DPR 25-18: Walmart Market Avon Avenue

Planning & Building Department Staff Report

For Hearing on January 26, 2026

A. PETITION NUMBER	DPR 25-18: Walmart Market Avon Avenue
B. APPLICANT	Walmart Real Estate Business Trust, c/o Michael Rabinowitch
C. LOCATION	1439 South Avon Avenue, Avon IN 46123 Lot 2 in Governors Row Road Extension at Turner Trace

Exhibit B – Revised Site Plan (5-January-2026)

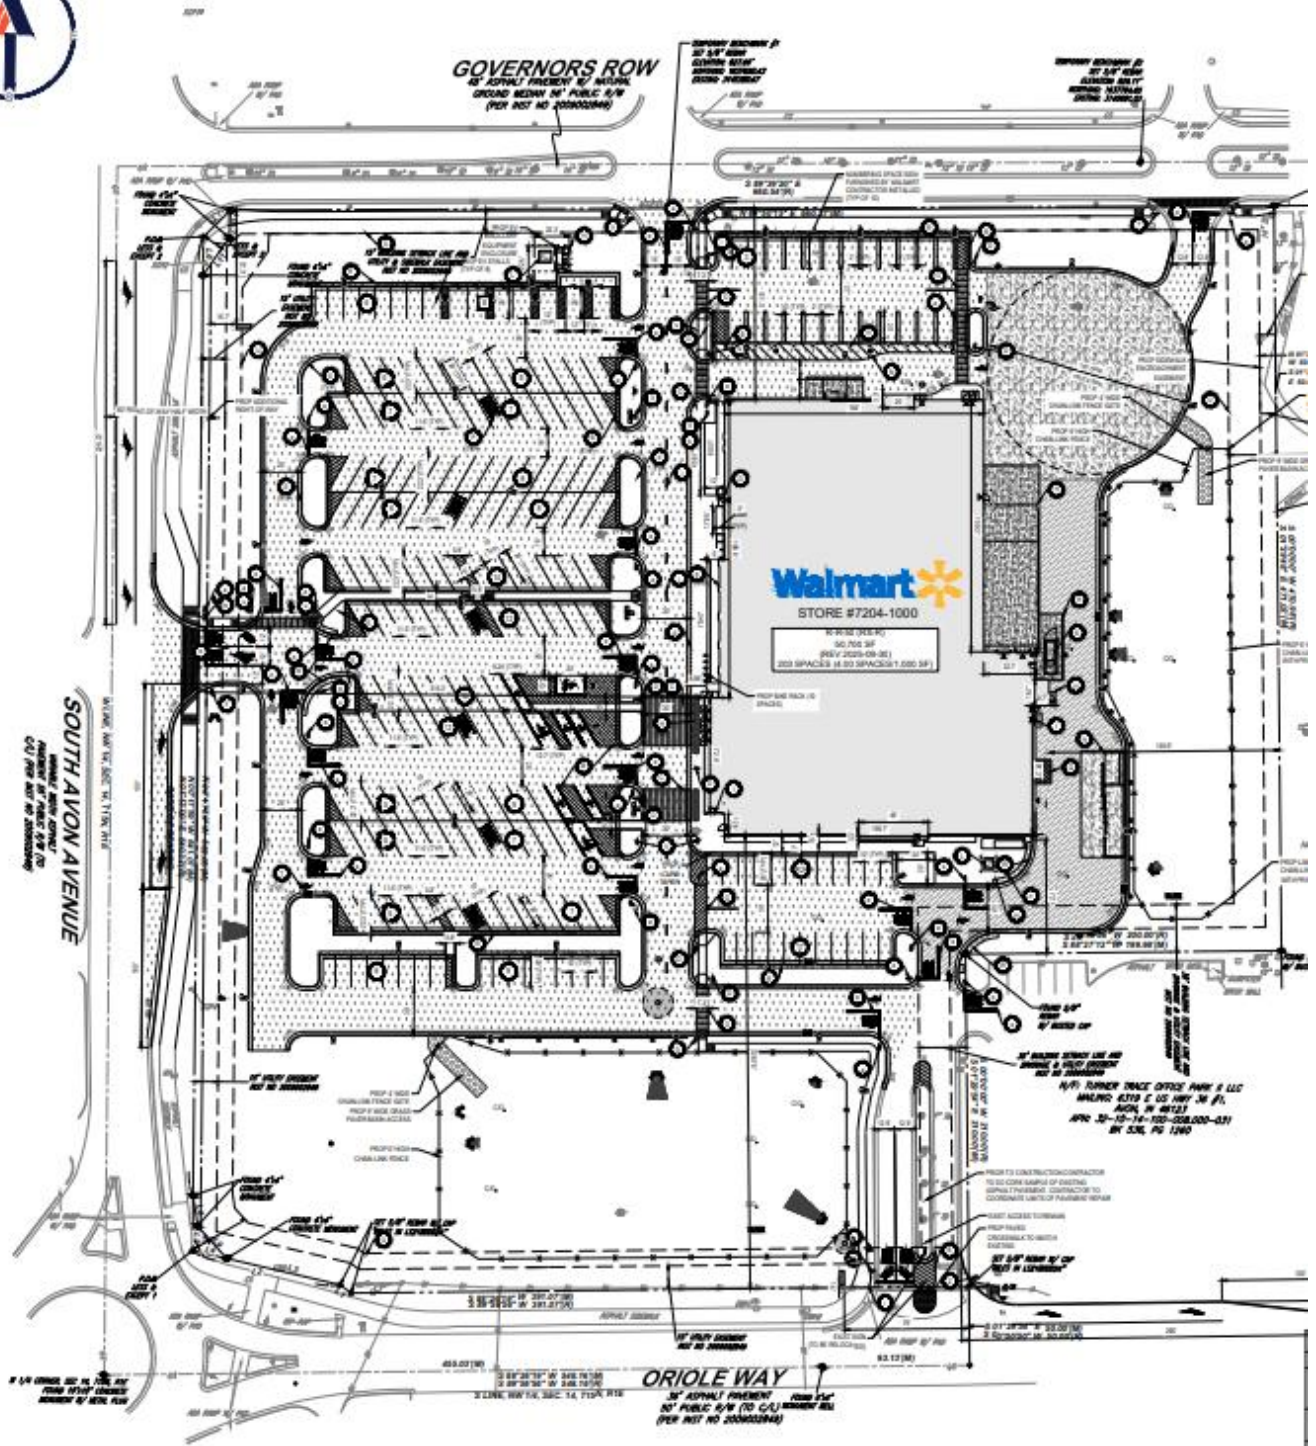
a) **Parking:** The site plan indicates the provision of 225 off-street vehicle parking spaces, with eight (8) of those being reserved accessible spaces. UDO Table 6.3 specifies that a minimum of 2.5 spaces per 1,000 square feet of gross floor area for a grocery store or other retail use, thus, a minimum of 127 spaces would be required for the proposed 50,700-square foot store. Based on the overall number of spaces provided, a minimum of seven (7) reserved accessible spaces would be required.

b) **Loading:** Retail buildings between 7,500 and 75,000 square feet are required to provide a minimum of one (1) dedicated loading space. The site plan indicates two (2) dedicated loading spaces meeting the spatial requirements for tractor-trailer deliveries.

c) **Bicycle Parking:** The UDO requires one bicycle rack per every twenty (20) required vehicle parking spaces, thus, six (6) bicycle racks would be required. While the

revised site plan shows bicycle racks in a compliant location, the plan only indicates five racks. At least one additional rack would be required.

Per UDO 6.7(B)(4), each parking lot landscape island must have a minimum of one tree. The revised landscape plan is still deficient of this standard.

A further revised landscape plan should be submitted to demonstrate compliance with the foundation planting and interior parking lot landscaping requirements.

Exhibit C2 – Areas Deficient of Foundation Planting Requirement

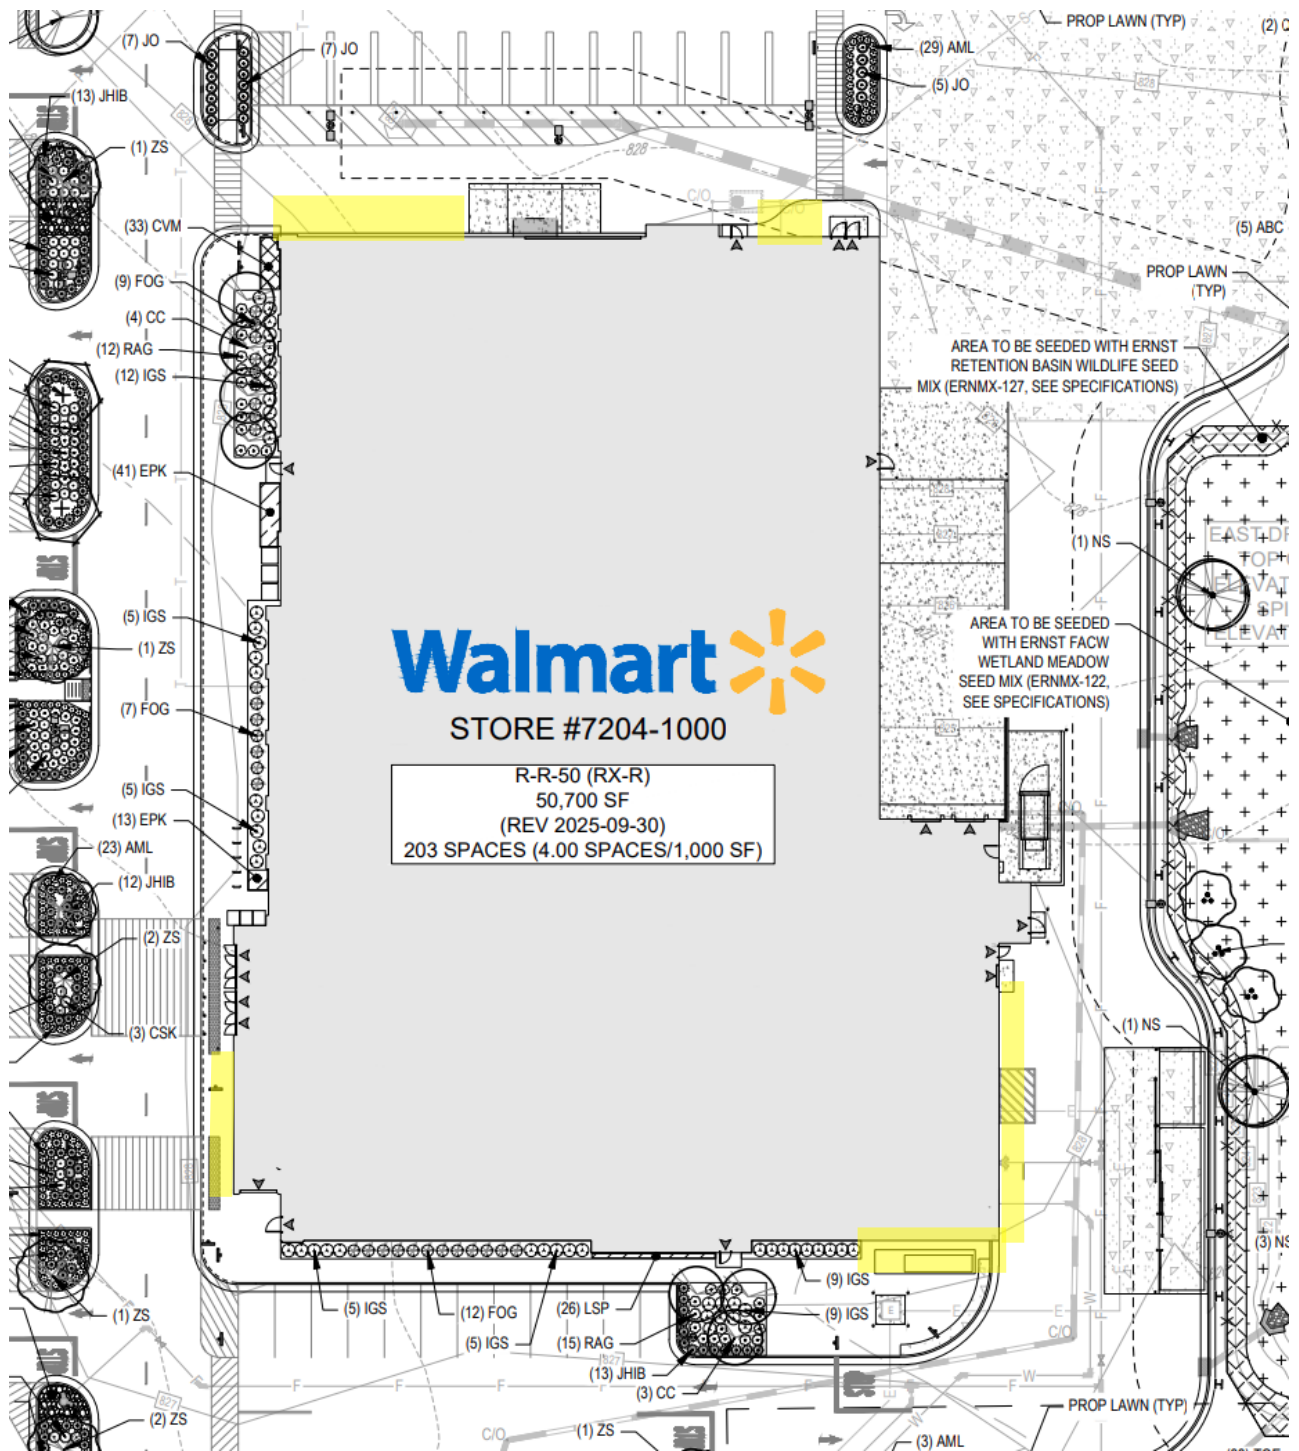
Per UDO 6.5 (A), a minimum five-foot planting area must be provided around the perimeter of the building, excluding access to the buildings, such as loading areas and doorways. The landscape plan submitted subsequent to TAC review has increased the proposed foundation planting areas, but is still deficient along several portions of the building (see Exhibits C1 & C2).

2. Prior to issuance of a building permit, a revised landscape plan shall be submitted, requiring approval by the Administrator, indicating compliance with all landscaping standards of the UDO.

Exhibit E – Aerial Photo w/ Measurements of Proposed Driveway Separation

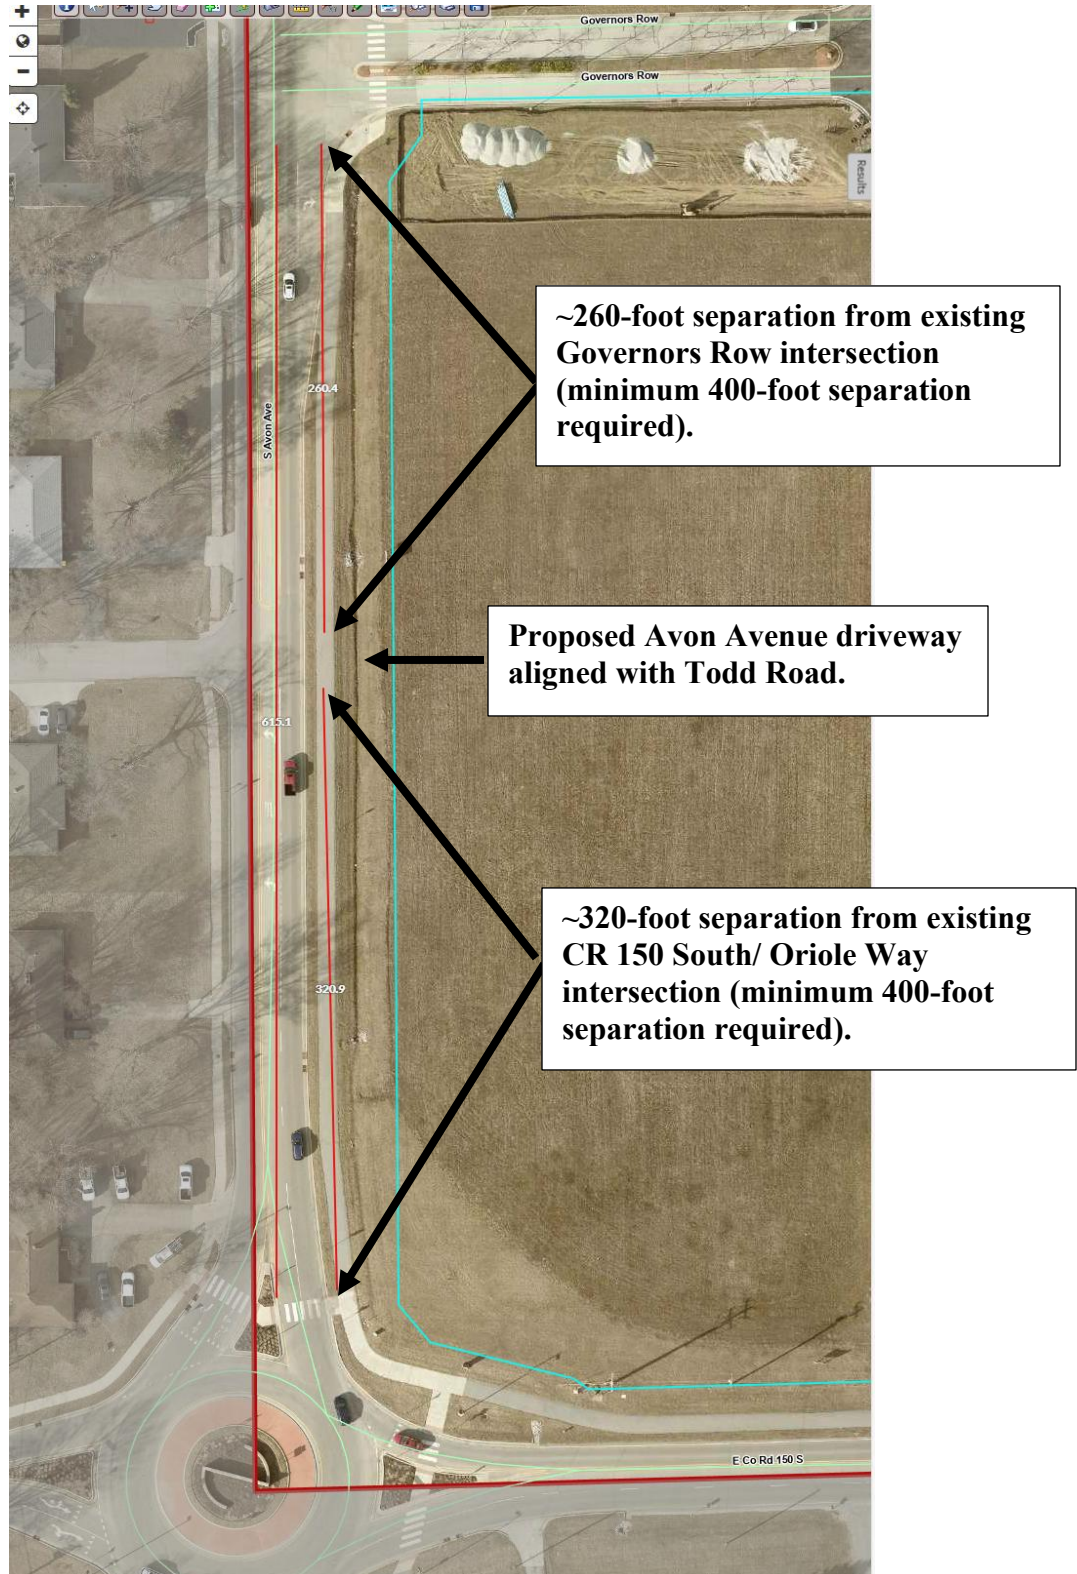
Waiver of Design Standards of UDO 7.21(E)(1), to allow for a new full-access commercial driveway onto Avon Avenue being ~260 feet from Governors Row and ~320 feet from County road 150 South/ Oriole Way (minimum 400-foot separation from each existing intersection required).

It is the opinion of the Town's Public Works Director and consulting traffic engineer that inadequate spacing of intersections along an arterial street with a 45 MPH speed limit would increase the risk of collisions and injuries. Staff believes this finding would not be met.

The Town's consulting traffic engineer indicates that, in addition to not meeting the Town's minimum standard, the proposed alternative would also be deficient of the 360-foot separation standard for a 45 MPH roadway that is indicated in INDOT's Driveway Permit Manual. Staff believes this proposal does contradict the intent of the Town's public street and access design standards.

While the property's frontage is not lengthy enough to meet the separation standards for a new direct access point to Avon Avenue, the site is already served by driveways onto County Road 150 South/ Oriole Way and onto Governors Row, both of which provide full access to/from Avon Avenue.

The existing Todd Road intersection was constructed several decades ago prior to incorporation of the Town of Avon. Adding a tenfold increase in traffic turning onto Avon Avenue at the peak hour, as the petitioner's Traffic Impact Study indicates, would decrease traffic safety and flow. Thus, the proposed waiver would not enhance the surrounding area.

Staff recommends denial of this waiver request.

If the requested waivers are not approved, staff recommends that additional conditions would be needed requiring revised plans meeting the lighting standards and to remove the proposed driveway access onto Avon Avenue.

Exhibit G – Site Photos

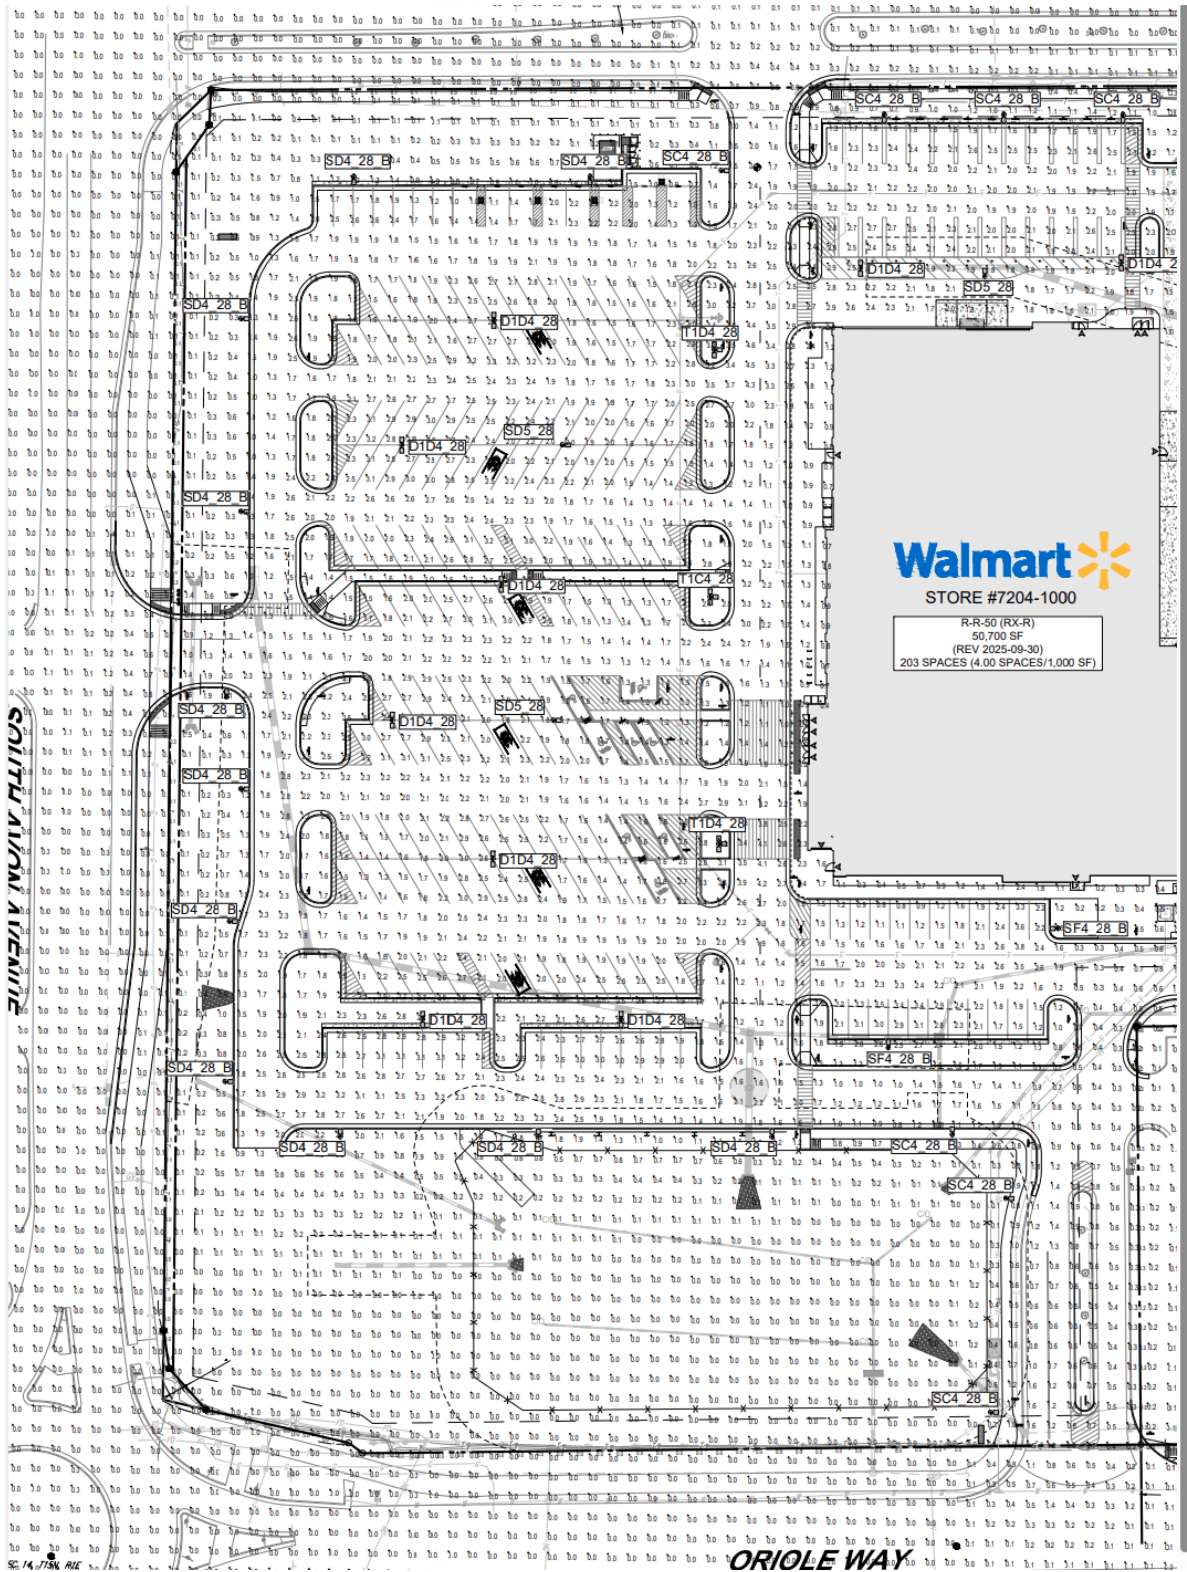
After evaluating the proposed development plan, the petitioner's TIS, and comments from the Town's consulting traffic engineer and Public Works Director, the Town opposes the requested waiver for direct access to Avon Avenue (see Exhibits E & G), and the Town has determined that the property owner should construct the following necessary improvements concurrently with development of the site.

- a) The intersection of Avon Avenue and Governors Row should be converted to a roundabout.
- b) Governors Row should be widened to a four-lane cross-section from Avon Avenue to the eastern Governors Row driveway to the property.
- c) Speed humps should be installed on Governors Row between the site's eastern Governors Row driveway and Turner Trace Place, and on Turner Trace Place South, just south of Lockford Walk North.
- d) A right turn lane should be constructed to the Town's standards on westbound County Road 150 South/ Oriole Way to the existing driveway.
